Sansui Europe Service Information

SSI-0004E

Models : - 9090, 8080

FIG. 1

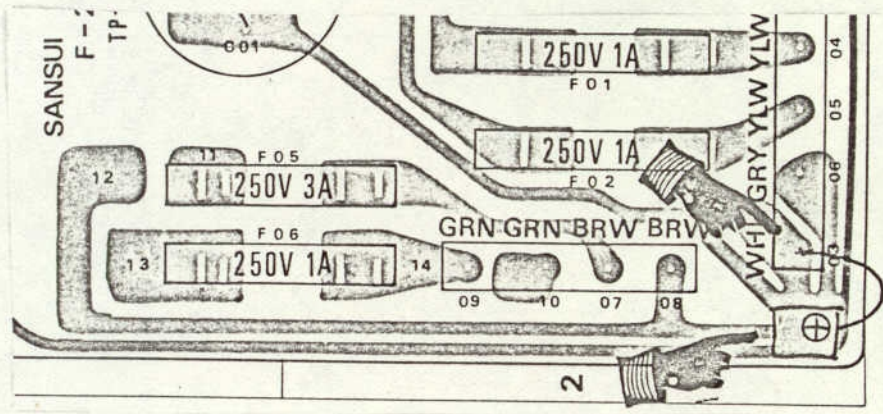
- Resistors R13 and R14, 10 Ohms have to be replaced by special fusing resistors of 4.7 Ohms 1/2 W. See fig. 1.
- The jumper connecting some relay contacts to earth, as shown in fig. 1, has to be removed.

FIG. 2

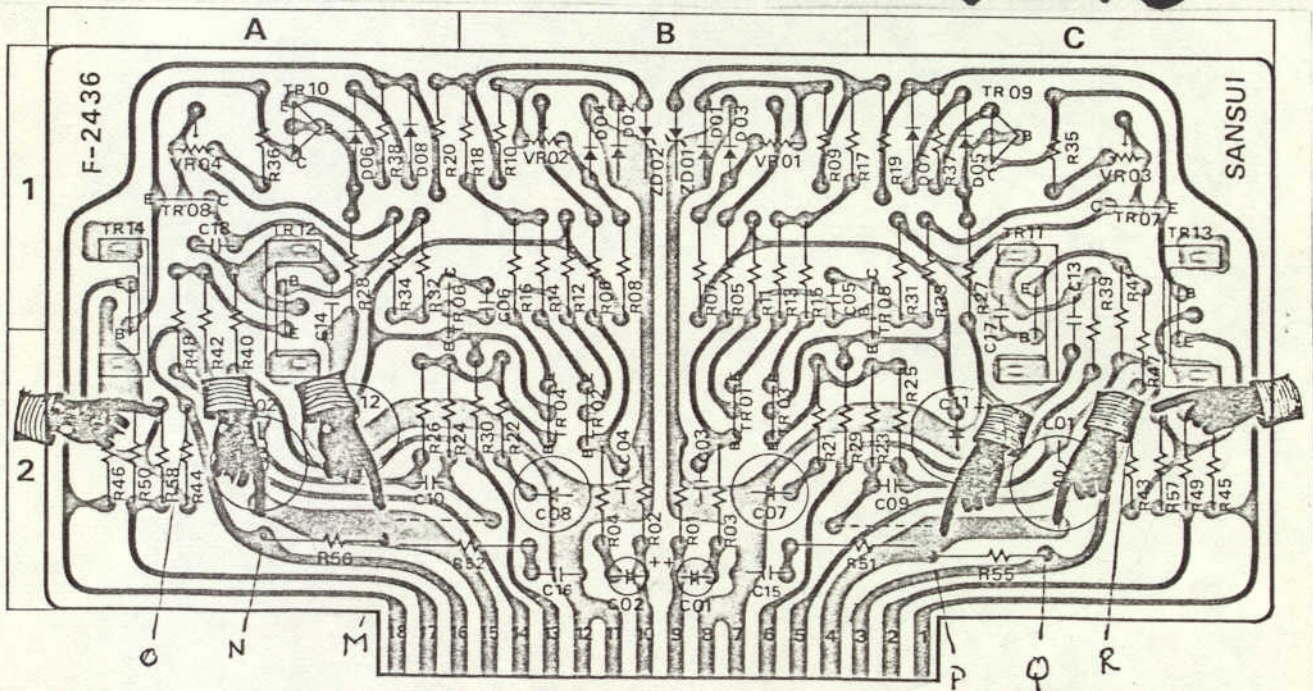
3. The earth contact on P.C.B. F-2546 can be ameliorated by soldering a piece of mesh-lead or any piece of thick, well-conducting wire, from point O3 (or O6) to the adjacent earth lug, as shown in fig. 2.

FIG. 3

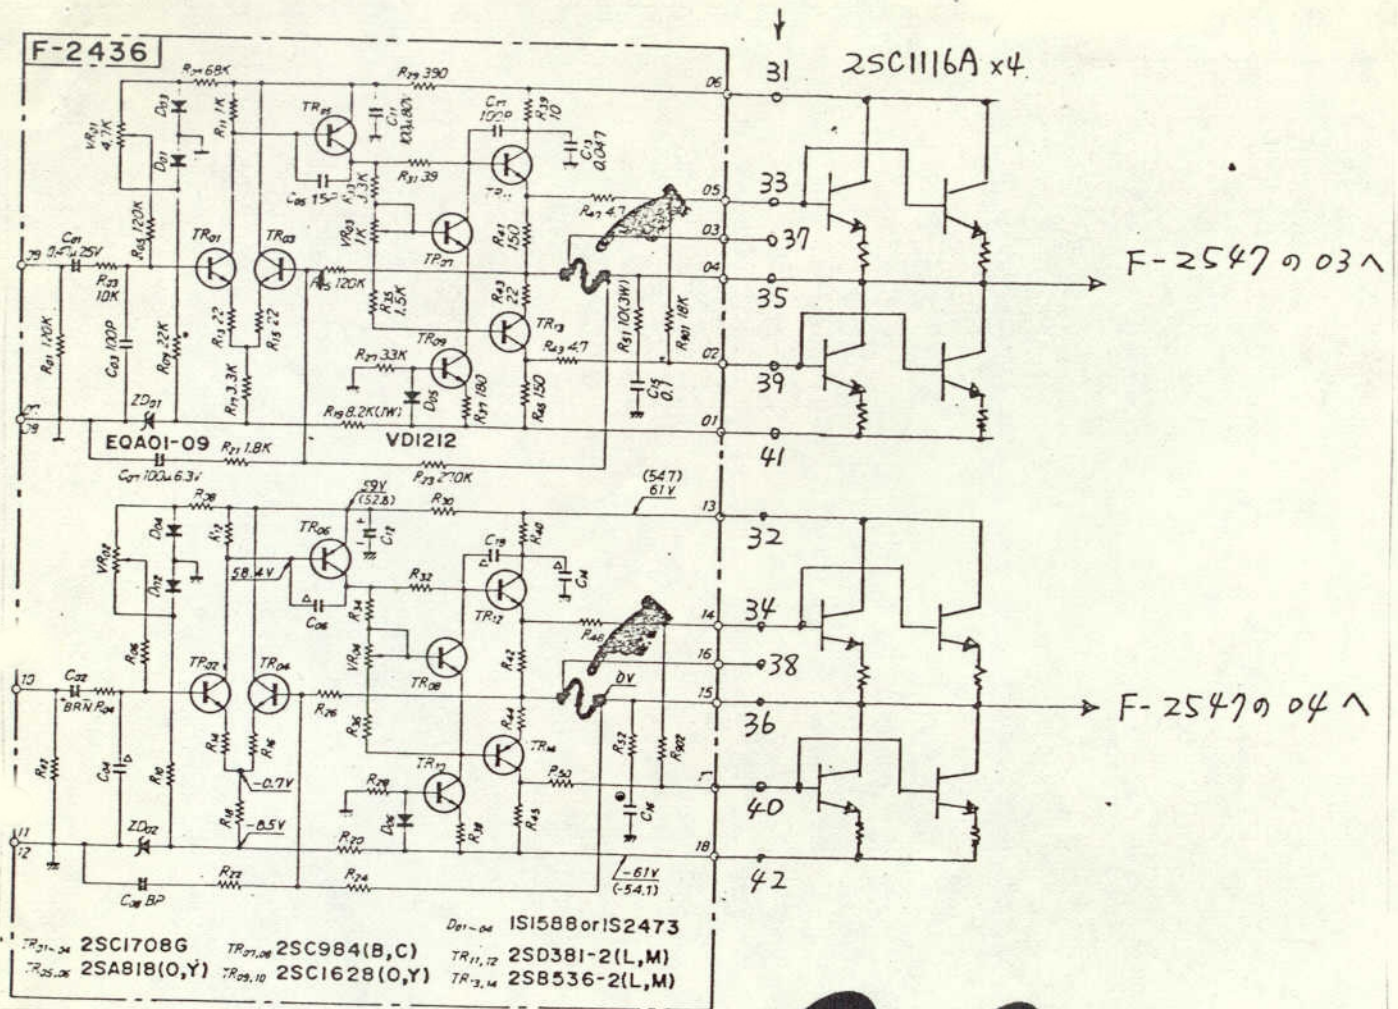
- Connect one wired-in fuse from point M on P.C.B. F-2436-1 (See fig. 3) to point N or to point O, depending upon the position of resistor R44.

- Connect one wired-in fuse from point P on P.C.B. F-2436-1 (See Fig. 3) to point Q or to point R, depending upon the position of resistor R43.

FIG. 4

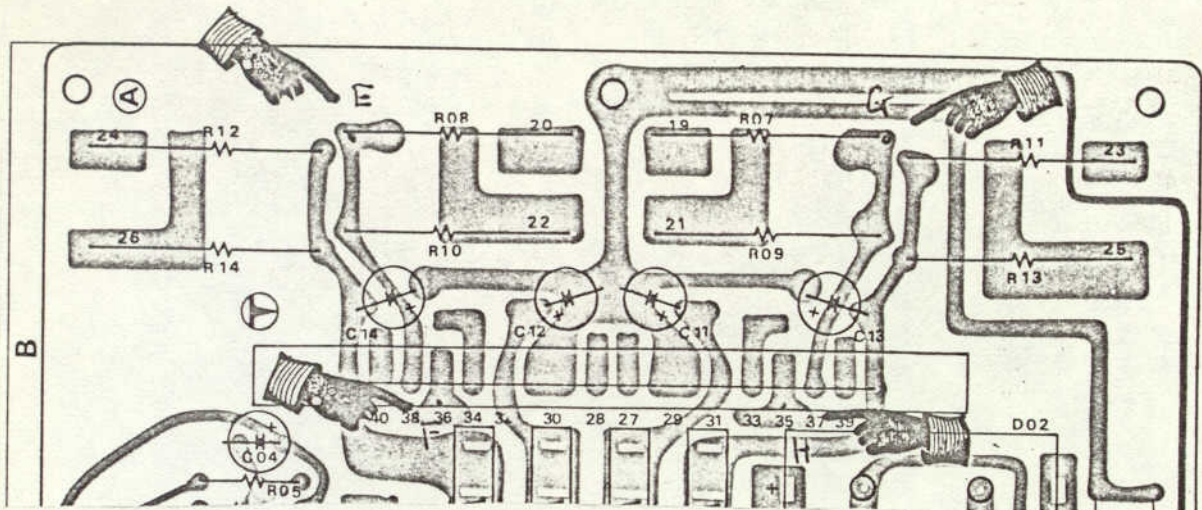
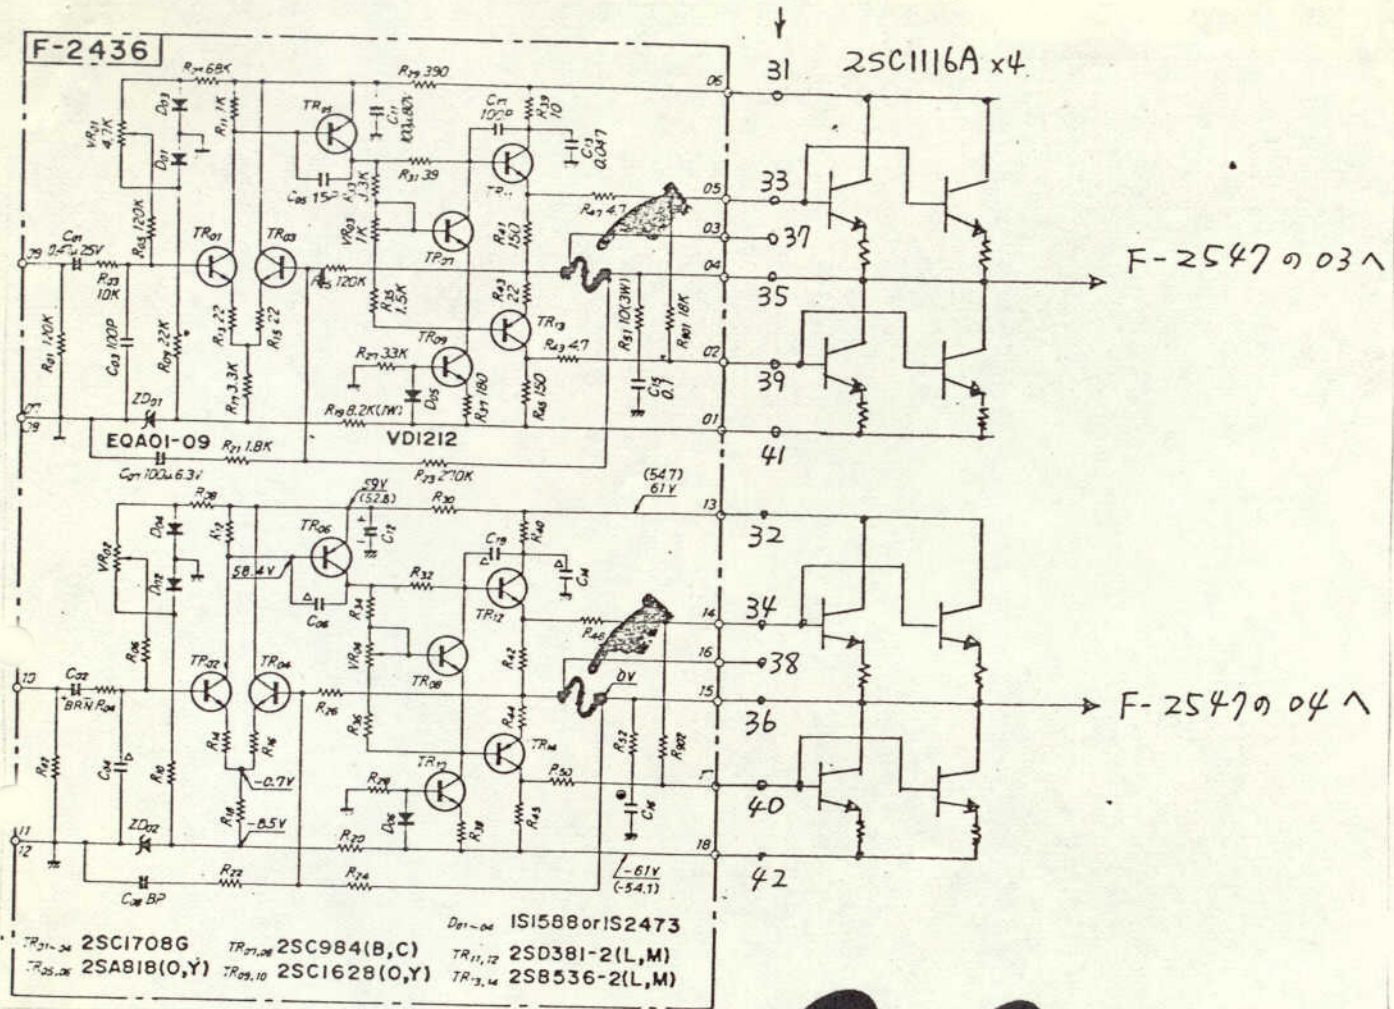
- It is also possible that these connections are made, like shown on fig. 4, from point E to point F and from point G to H. Even so these jumpers should be removed.

- Make the following connections with normal wire :

- from point 04 on F-2547 to point 35 on F-2546

- from point 03 on F-2547 to point 36 on F-2546
